# Genesee County Land Bank Authority Blight Elimination Program Request for Proposals- LB 19-010 Environmental Abatement, Demolition and Restoration of 4615 Western Rd, Former Shady Acres Mobile Home Park ADDENDUM #1

#### May 6, 2019

Addendum #1 Bid Number: LB 19-010

#### **AREA DESCRIPTION- Refer to Site Drawing on SUBJECT PROPERTY MAP**

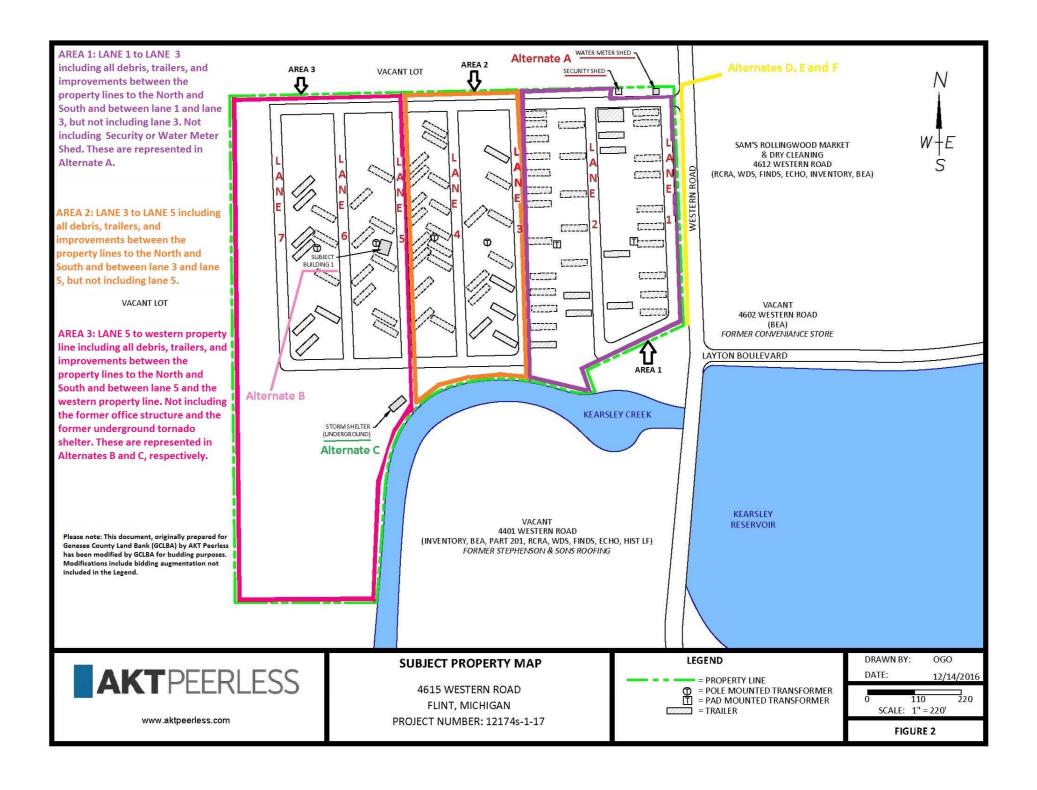
AREA 1: LANE 1 to LANE 3 including all debris, trailers, and improvements between the property lines to the North and South and between lane 1 and lane 3, but not including lane 3. Not including Security or Water Meter Shed. These are represented in Alternate A.

AREA 2: LANE 3 to LANE 5 including all debris, trailers, and improvements between the property lines to the North and South and between lane 3 and lane 5, but not including lane 5.

AREA 3: LANE 5 to western property line including all debris, trailers, and improvements between the property lines to the North and South and between lane 5 and the western property line. Not including the former office structure and the former underground tornado shelter. These are represented in Alternates B and C, respectively.

BUMPER & PARKING RAILS, AND MISC. WOOD POSTS

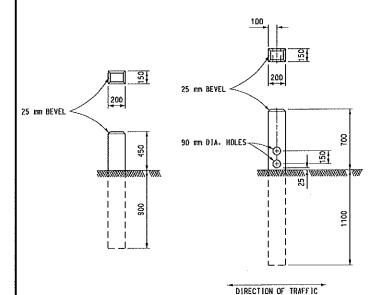
F	Obtain necessary permit(s), pay fee(s), and install wooden guard posts per Michigan Department of Transportation (MDOT) specifications at intervals leaving 3 feet in between each and in accordance with City requirements along Western Rd. from Layton Dr to approach on North side of site. Procure and install a 28' Wide Double Drive Bar Gate w/4" Sch 40 hinge posts and 2" hold back posts at approach in approach on North side of site.	LS	1	\$
